ORC STAFF RECOMMENDING REPORT

ID Ref: A946493 File No: 2008.238

Prepared For: Staff Consents Panel Prepared By: Ralph Henderson 08/03/2017

Subject: Application by Queenstown Lakes District Council to vary

Figure 2: Appendix 1 of consents 2008.242 and 2008.243 – Plan of disposal field in Shotover Delta

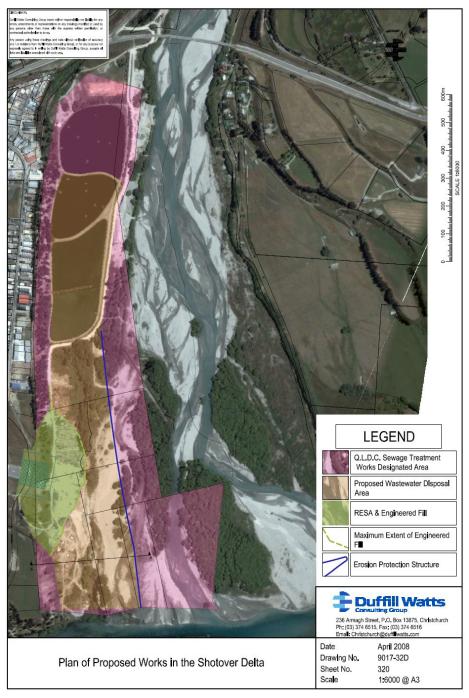
The main differences between that consented discharge and that now proposed is the LPED-DAD system is located outside the Otago Regional Council (ORC) revetment and will be located north east of the land discharge area previously consented (RM13.215.03; RM13.237/2008.238), between the engineered ORC revetment located south of the maturation pond and the Shotover River (see Figure 3). The disposal system will not rely upon additional treatment in ground to improve water quality and will use natural silts, sands and gravels below ground rather than engineered gravel fill raised above ground level.

2008.242	The structure shall be located within the proposed wastewater disposal
Condition 7	area identified in Appendix1 and sized as identified in Appendix 2
	attached to this consent.
Variation	The structure shall be located within the proposed wastewater disposal
Condition 7	area identified in Appendix 1 and sized as identified in Appendix 2
	Appendix A attached to this variation to the consent.

2008.243	The works shall only occur within the proposed wastewater disposal
Condition 6	area identified in Appendix 1 attached to this consent.
Variation	The works shall be located within the proposed wastewater disposal
Condition 6	area identified in Appendix 1 and sized as identified in Appendix 2
	Appendix A attached to this variation to the consent.

Figure 4: Proposed LPED Design (see Appendix 1)

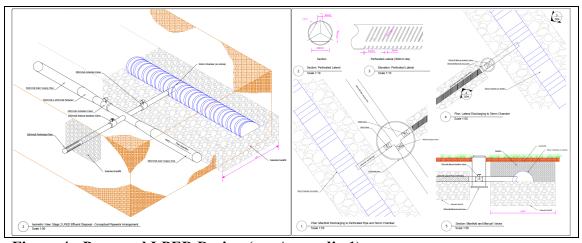
The proposed system has been designed to accept a maximum discharge of up to 430L/s. This represents the anticipated maximum flow rate for Stage 3 of the proposed development, and is based on the available hydraulic loads and including a safety factor. The peak design rate is approximately 5 m/day on the trench area.

The average loading on the effective trench area will be 1.2 m in Stage 1 and 1.7 m in Stage 3, however the maximum discharge loading rate when averaged across the total area of the disposal field will be 1,000 mm per day. The applicant notes the design of

the disposal field shown in Figure 4 may be subject to further modification during development and the proposed plans should be in general accordance with the designs presented.

Figure 6: Location of test pits and soil profiles

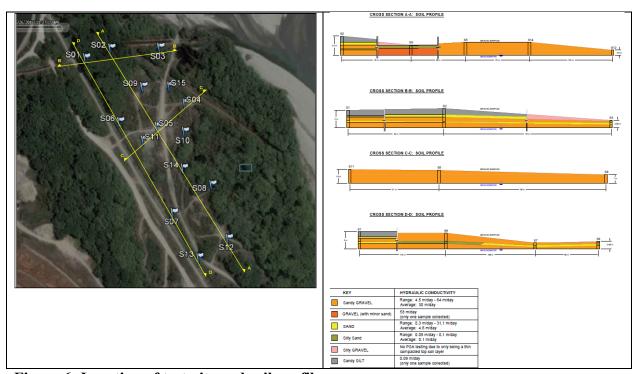
The PSA results indicate that the soils in the bed of the proposed new disposal are primarily sandy gravels and therefore the hydraulic conductivity is estimated to be within the range of 4.5 m/day to 64 m/day (see Figure 6 and Table 2).

As noted in Section 2.2.3 of this report, investigations of the site indicated that an infiltration rate over the site of 10 m/d was achievable. The applicant has designed to 50% of this figure as a factor of safety.

Figure 7: Proposed groundwater monitoring

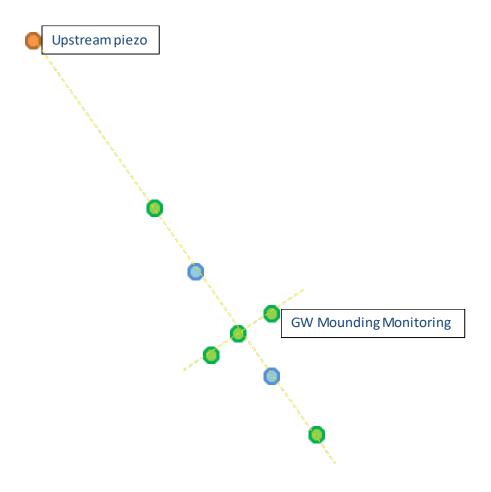
Council's RSU unit have proposed the monitoring of groundwater be undertaken to determine potential impacts on groundwater quality and levels. RSU recommend a monitoring layout generally consistent with that shown in Figure 7. Monitoring upstream will provide a baseline in terms of groundwater height and quality. The orange and green markers are considered a minimum requirement but the blue markers would be advisable given it is anticipated that the proposed disposal field will be expanded in stages.

The layout of the monitoring bores will be agreed with Council as part of the requirements of Consent 2008.238.V1 and RM13.215.03 to provide an Operations and Management Manual outlining how the system will be managed and monitored to the satisfaction of the Consent Authority, and to provide an annual report of operations.
